Product Change Notice (PCN)

Subject: Part Marking Change for the Listed QML Products

Publication Date: 4/27/2018

1. ISL70040SEHVL GanFET Low Side Driver

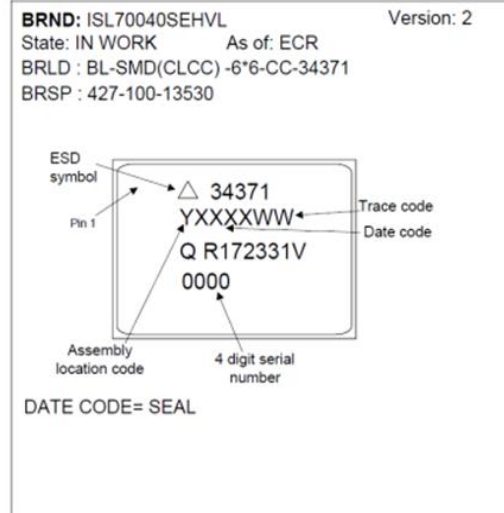
The marking for the products listed below will be changed (per appendix A). As space permits either the Renesas Electronics America Inc cage code (34371) or the registered trademark “i” will be marked on the product.

10. ISL71590SEHVF Temperature Sensor

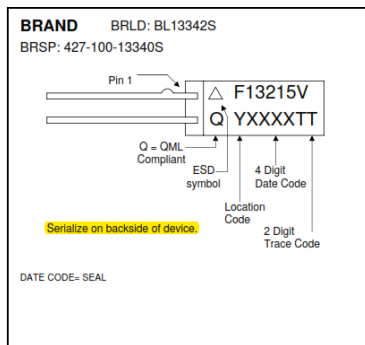
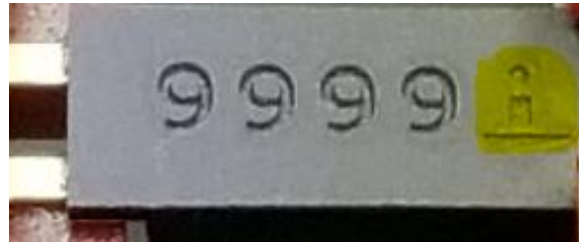
After: (logo will be on the backside with the serial number)

11. ISL73590SEHVF Temperature Sensor

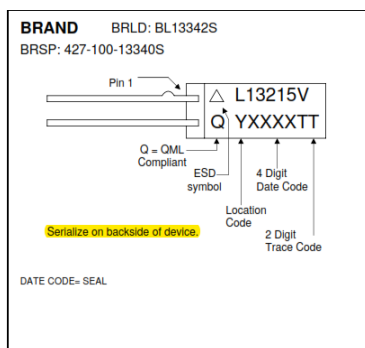
After: (logo will be on the backside with the serial number)
